**Rocky Flats Environmental Technology Site:  
Actinide Migration Evaluation (AME)**

Meetings: June 6 to 8, 2005

Advisory Group: Greg Choppin, David Clark, David Janecky, Leonard Lane

**Summary and Recommendations for Path Forward**

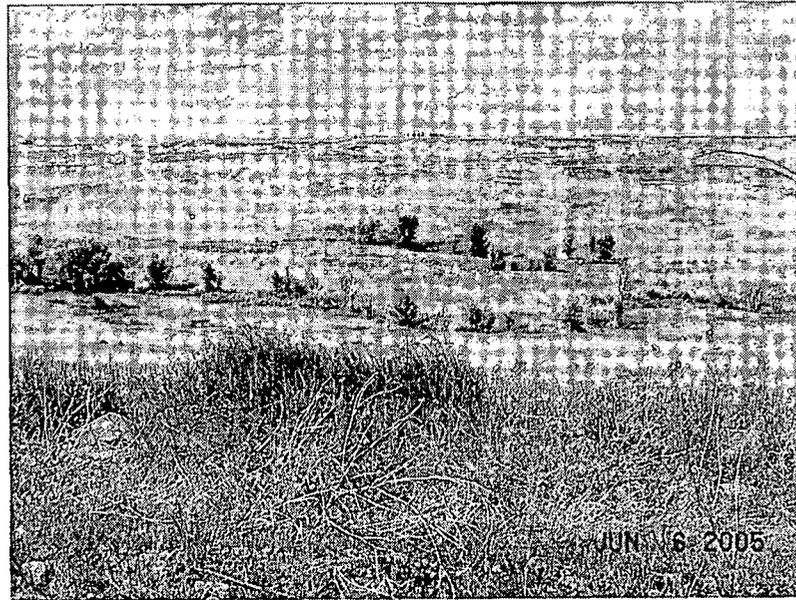
Figure 1. View to north across Woman Creek to the 903 Pad lip area. The top of the hillslope adjacent to the 903 Pad lip area does not appear to be re-vegetating as quickly as surrounding areas—green vegetation was not apparent during tour observations. This area appears to need further reseeding and revegetation efforts.

Figure 3a&b. A previously closed, up- and down-slope road near GS51 has been reopened, is eroding rapidly, and is delivering sediment to GS51 and also directly across the SID and into Woman Creek.

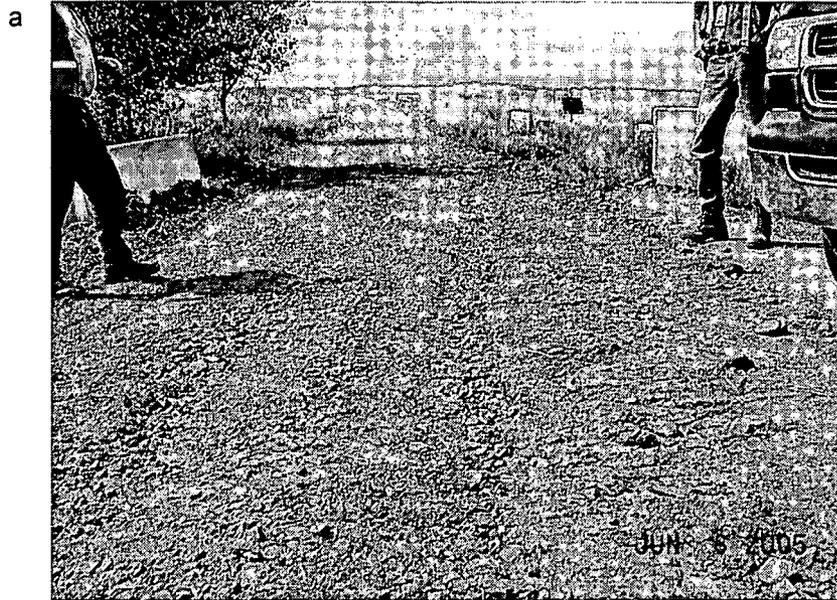
These pictures were taken looking to the north from the remediated area beside Woman Creek and Pond C-1. Surface water sampling station GS51 is uphill of the van, to the right of the road (see dark square of the solar power cell). The SID crosses the road under the camera in picture 3a and between the posts in picture 3b.

The GS51 drainage area shows a relatively high concentration of both plutonium and americium contamination. The level of contamination has increased significantly since the reopening of the road for the Pond C-1 project. The AME Advisors recommend re-closing of this road to obtain reduction of the contamination in GS51 (and GS52) and to develop long-term stability in this area.
